Floating Tap Incorporation Proposal for Annex 93A

May 2019

IEEE 802.3 100 Gb/s, 200 Gb/s, and 400 Gb/s Electrical Interfaces Task Force, Salt Lake City, Utah

Implementation of floating DFE taps in Annex 93A

Add parameter N_f which is the total reach of the DFE including floating taps

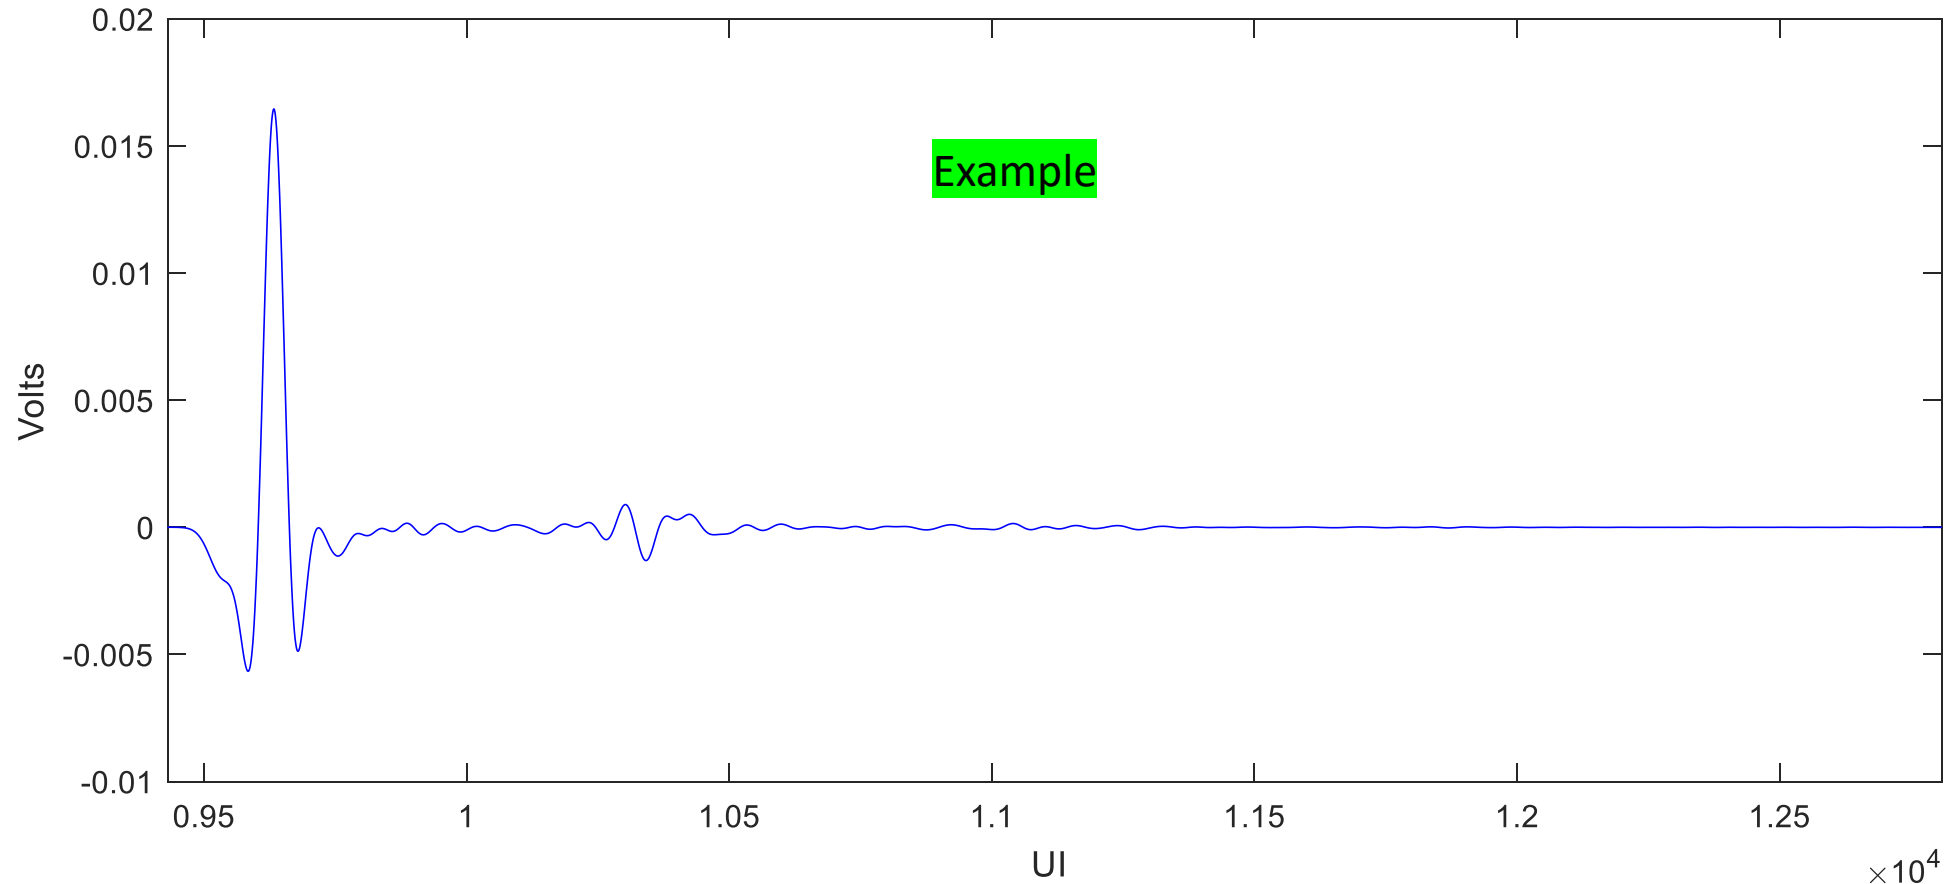
- ❑ Add a few parameters which represent aspects of floating taps in a DFE
- ❑ Small change to equation 93A-27
- ❑ Add a few lines describing how to determine the location of the floating DFE taps in 93A.1.6
 - Based on the few added parameters
- ❑ Referring section calls out these parameters

- a) Compute the pulse response $h^{(k)}(t)$ of each signal path k for a given $c(-1)$, $c(1)$, g_{DC} , and g_{DC2} using the procedure defined in 93A.1.5.
- b) Define t_s to be the time that satisfies Equation (93A–25). If there are multiple values of t_s that satisfy the equation, then the first value prior to the peak of $h^{(0)}(t)$ is selected. The coefficients of the decision feedback equalizer $b(n)$ are computed as shown in Equation (93A–26). If N_b is 0, then the $b(n)$ is considered to be zero for all n . **If N_f is not defined in the referring section then considered $N_f = N_b$.**

Adjust h_{isi} equation 93A-27

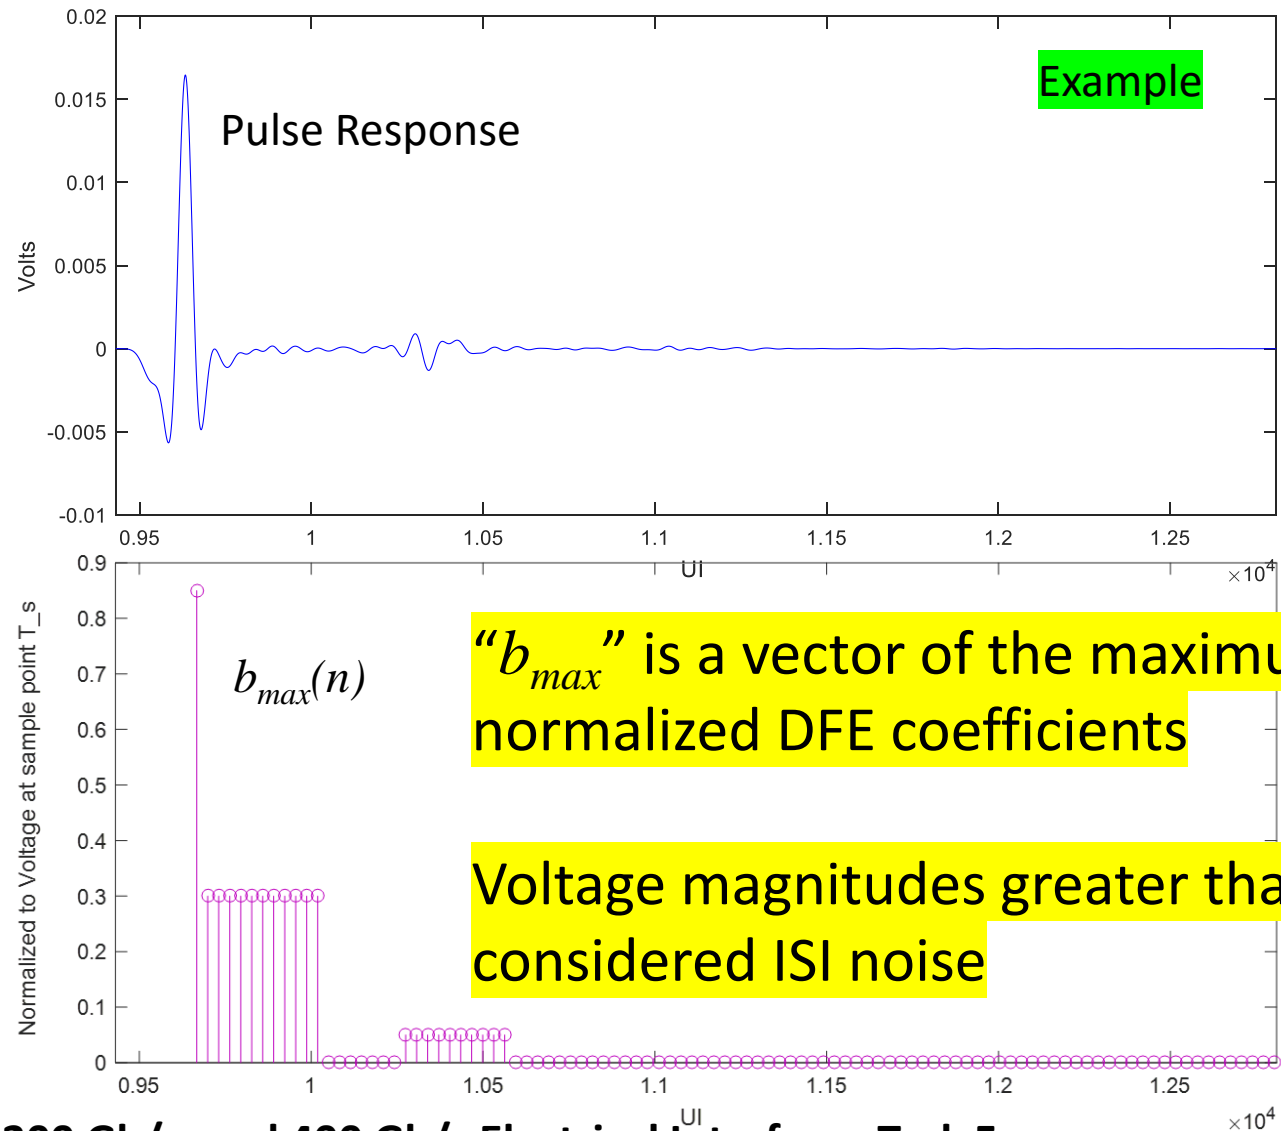
We will leverage b_{max}

The DFE action is controlled by vector $b(n)$

$$h_{ISI}(n) = \begin{cases} 0 & n = 0 \\ h^{(0)}(t_s + nT_b) - h^{(0)}(t_s)b(n) & 1 \leq n \leq N_f \\ h^{(0)}(t_s + nT_b) & \text{otherwise} \end{cases} \quad (93A-27)$$

Rules for Floating Tap Determination of $b(n)$

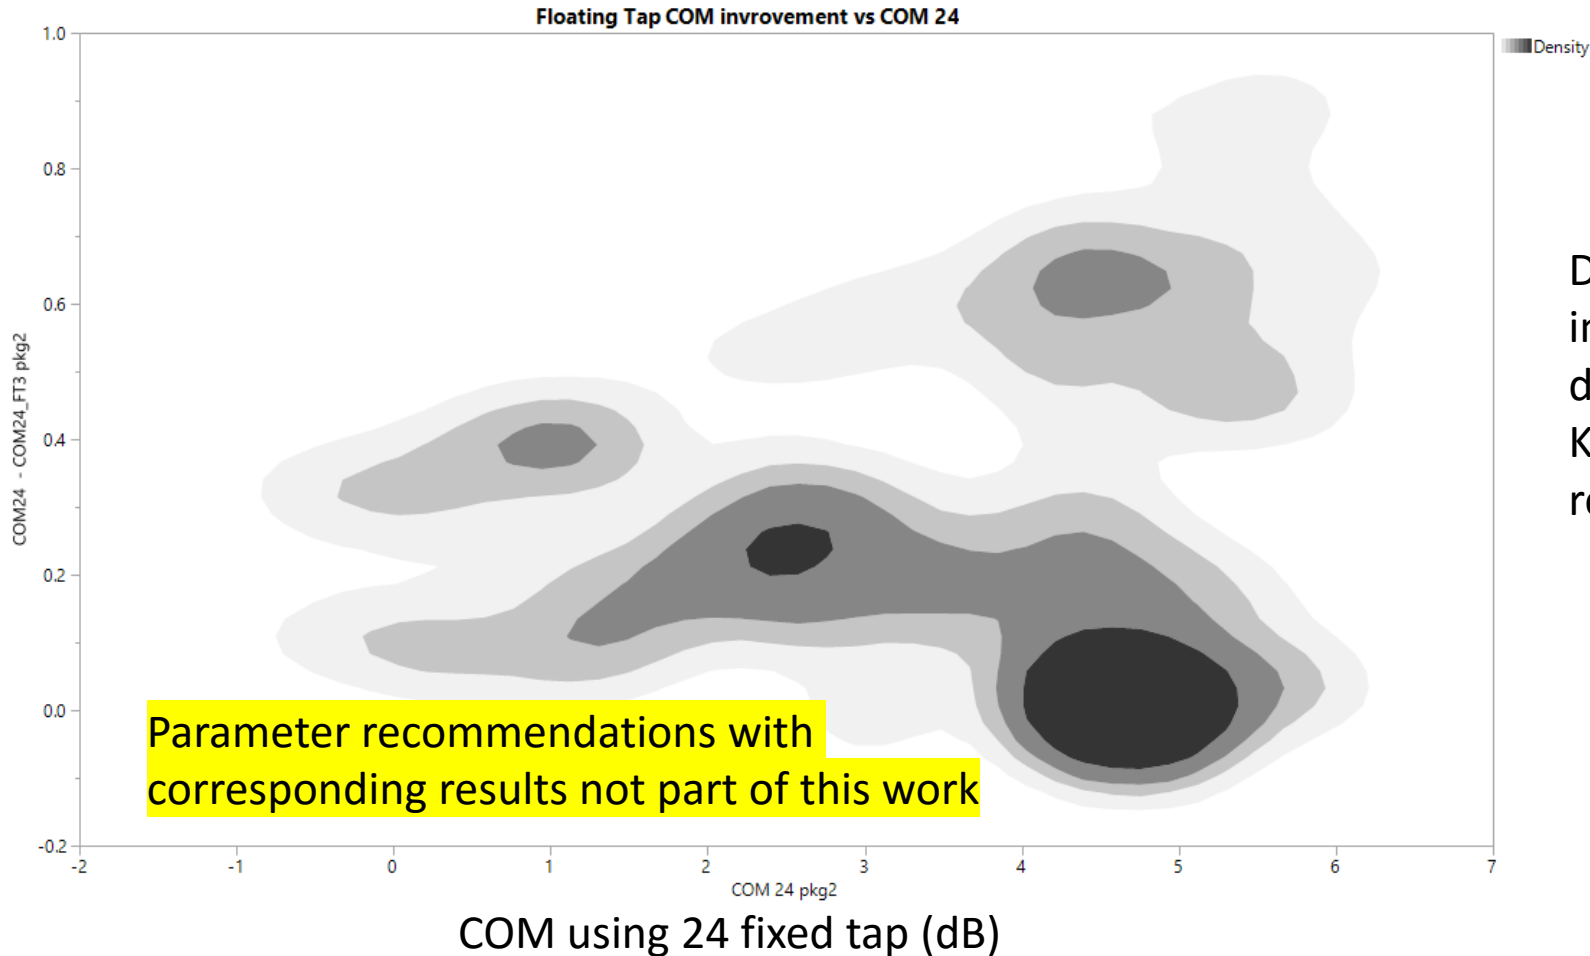
Determine the location of non-zero $b(n)$ corresponding to each of N_{bg} groups

2. Determine the value for N_{gx} which “minimizes” the $\sum h_{nf}(n)^2$

- Where $b(N_{gx} \dots N_{gx} + N_{gf}) = b_{maxg}$ and $N_b + 1 \leq N_{gx} \leq N_f - N_{gx}$

- I.e. set b_{max} for all the taps in the group

3. Find N_{gx} for each of N_{bg} groups by repeating step 2 not including locations $N_{gx} \dots N_{gx} + N_{gf}$
